- ADDENDUM #1 JUNE 18, 2025
- RE: EASTSIDE FIRE STATION Seismic Grant Upgrade Project #22.22.2
- FROM: HGE ARCHITECTS, Inc. 333 South 4<sup>th</sup> Street Coos Bay, Oregon 97420 541-269-1166

This Addendum forms a part of the Contract Documents and modifies the original Documents dated May 2025, as noted below. Acknowledge receipt of this Addendum in the space provided on the Bid Form. Failure to do so may subject Bidder to disqualification.

This Addendum consists of **SIX (6)** page(s) together with the following attachments:

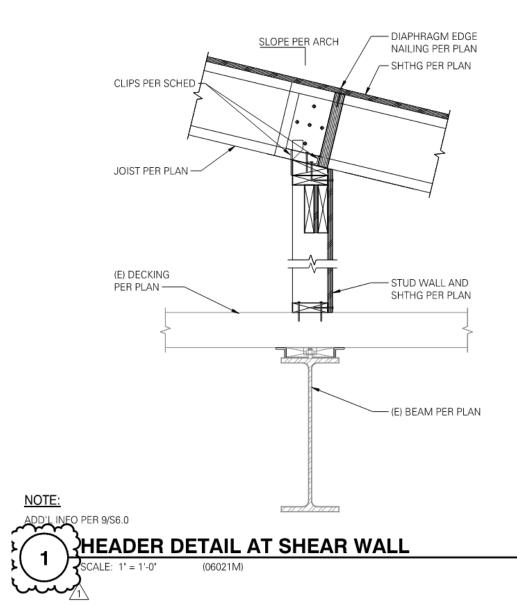
- 2. Sheet G0.2 General Information: DELETE Wall Type E.
- **3.** Sheet AD2.1 First Floor Demo Plan: REPLACE with attached revised sheet in its entirety. Revisions include:

- a. Added note and dimensions clarifying demo of existing concrete vault in northwest corner of Conference Room #3.
  - Added Demo Plan General Note to cut all existing exposed and abandoned bolt heads in concrete walls throughout building, patch & paint.

- c. Added second existing roof drain pipe and note to remove in Apparatus Bay, Room #8.
  - d. Added note at unreinforced masonry boiler room in Apparatus Bay to remove existing boiler system and all associated hydronic piping.

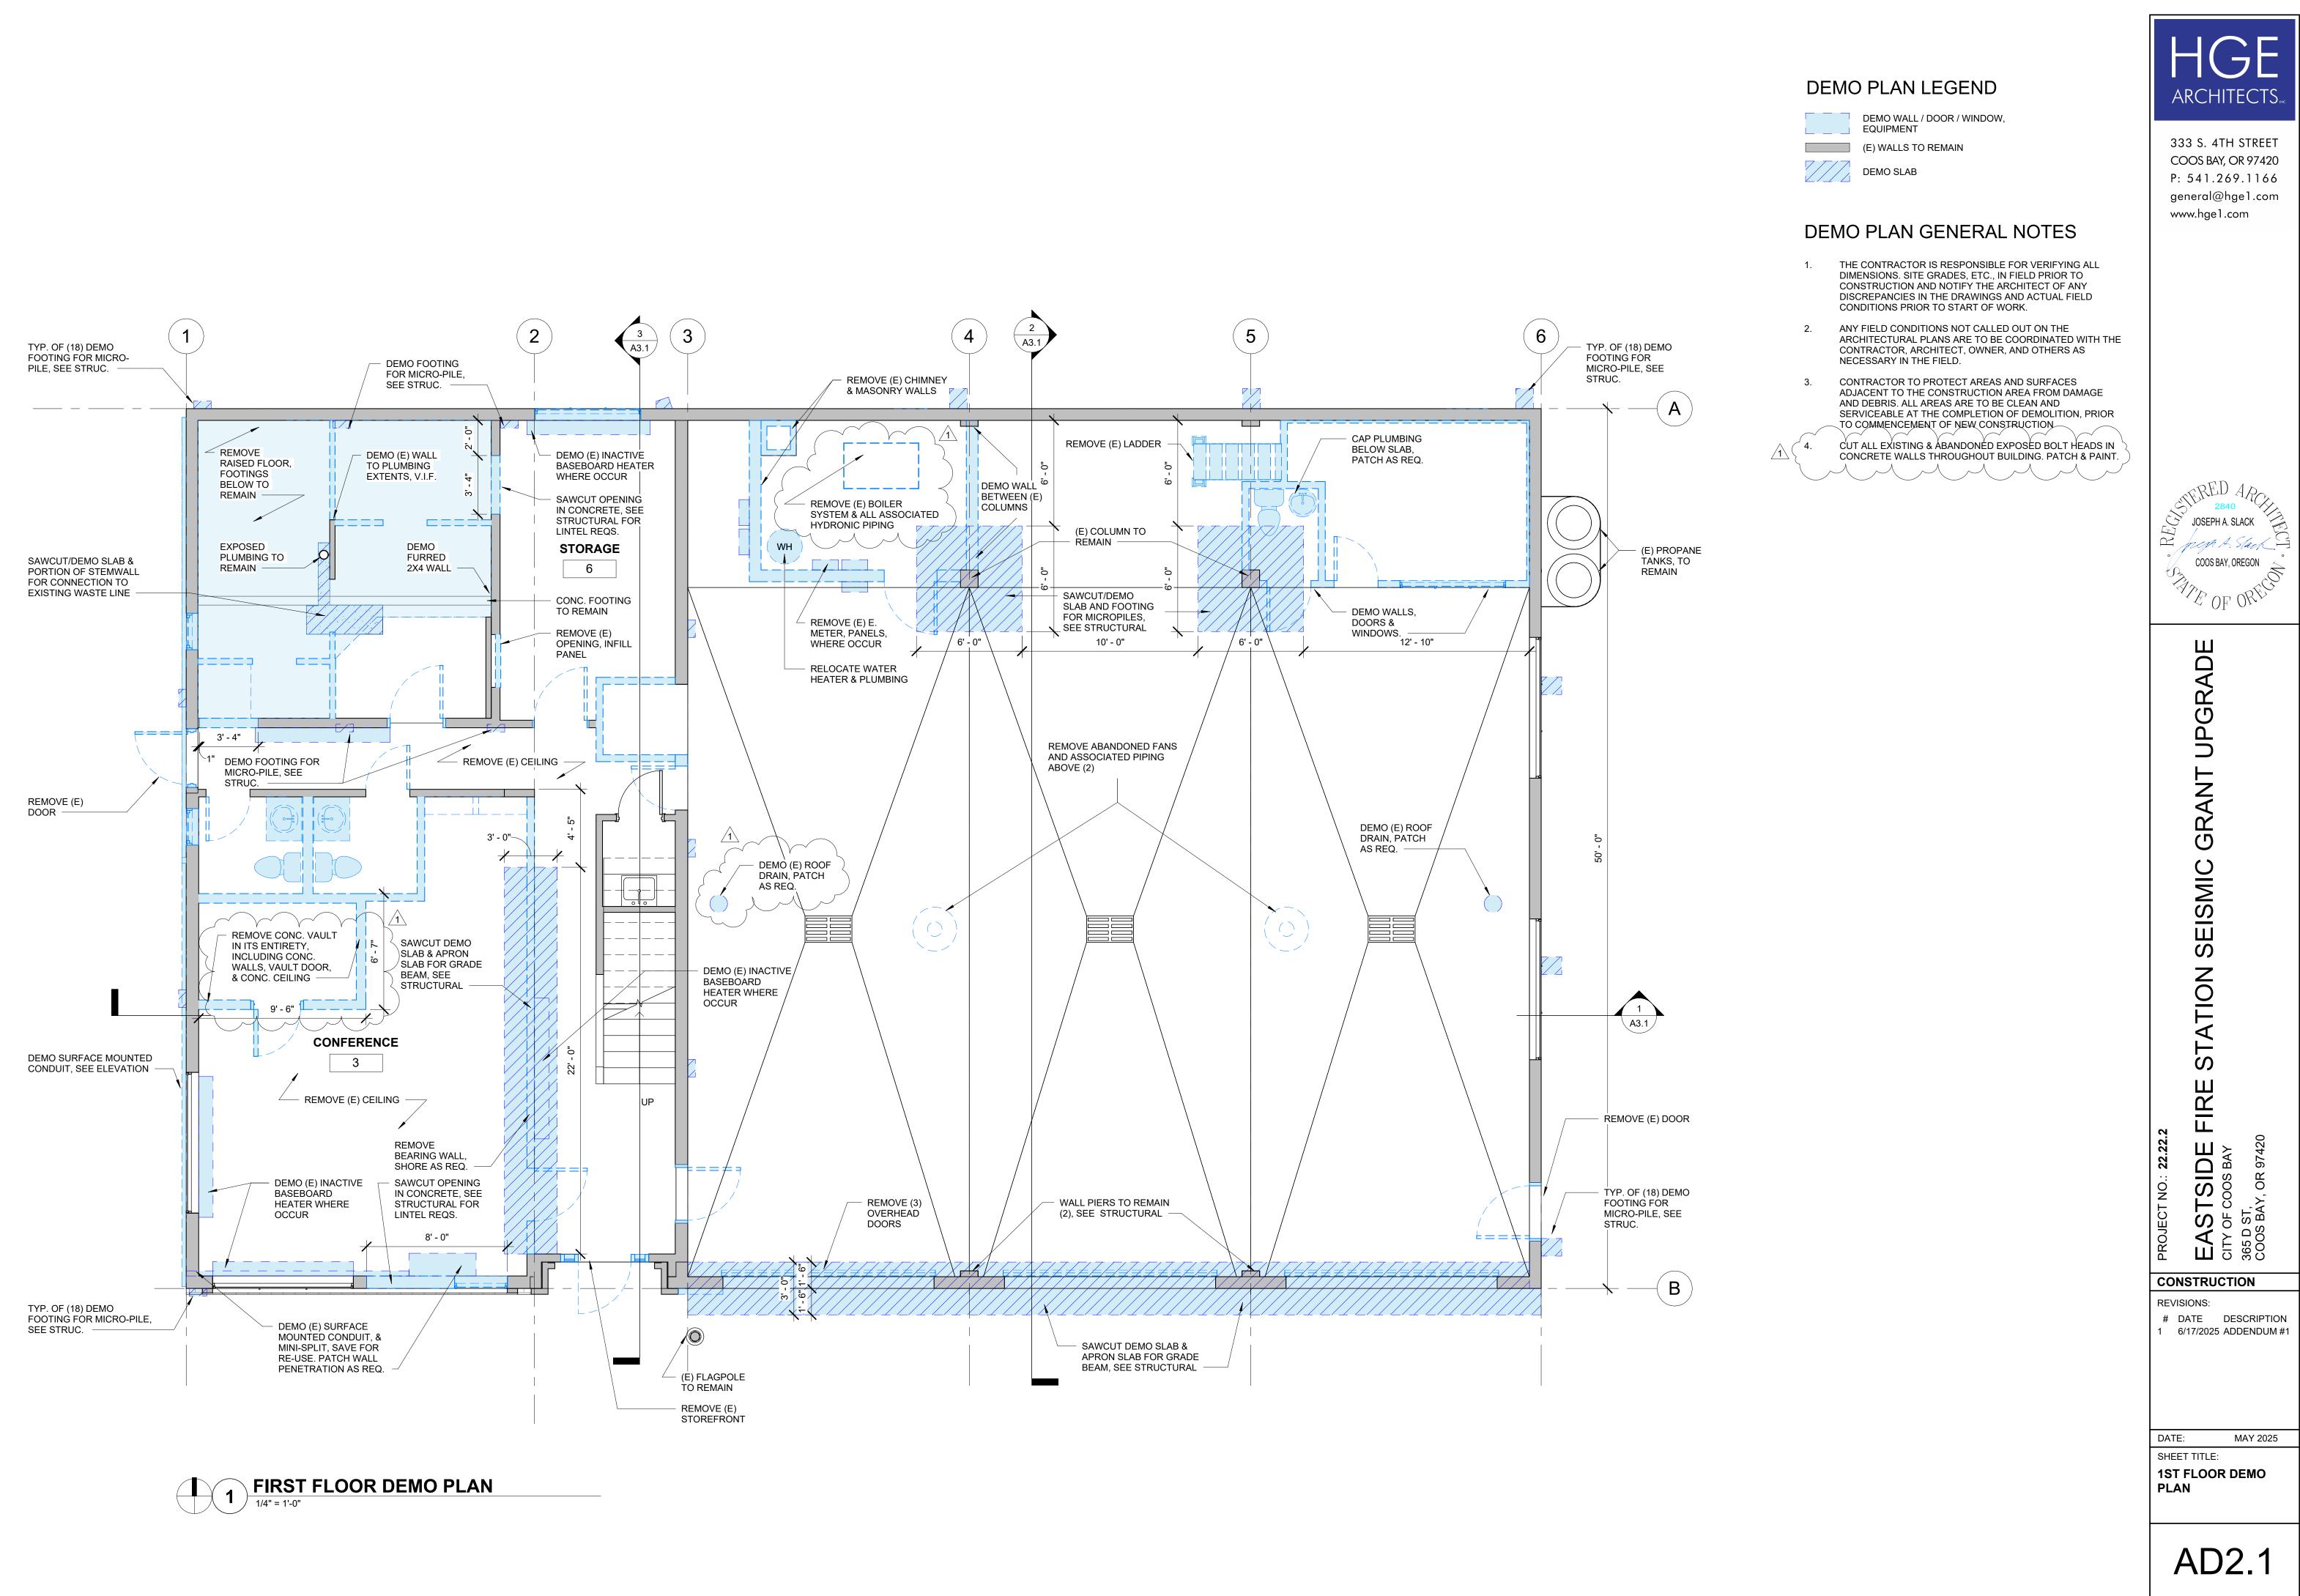
- b. At east-west attic wall access opening (per dimensions on A2.2 Second Floor Plan), ADD note, "CS14x7'-0" above and below opening."
- **9. Sheet S3.1 Structural Elevations:** REPLACE with attached revised sheet in its entirety. Revisions include:

- a. Added lintel and callout for Detail 6/S7.0 at east window opening head.
  - b. Added callout to Detail 11/S3.1.
  - c. Added Detail 11, Partial Elevation Interior South Elevation.

- d. Added HSS4x4x1/4 with BP1/2 top and bottom, with callout to Detail 5/S4.1, at jamb between window openings.
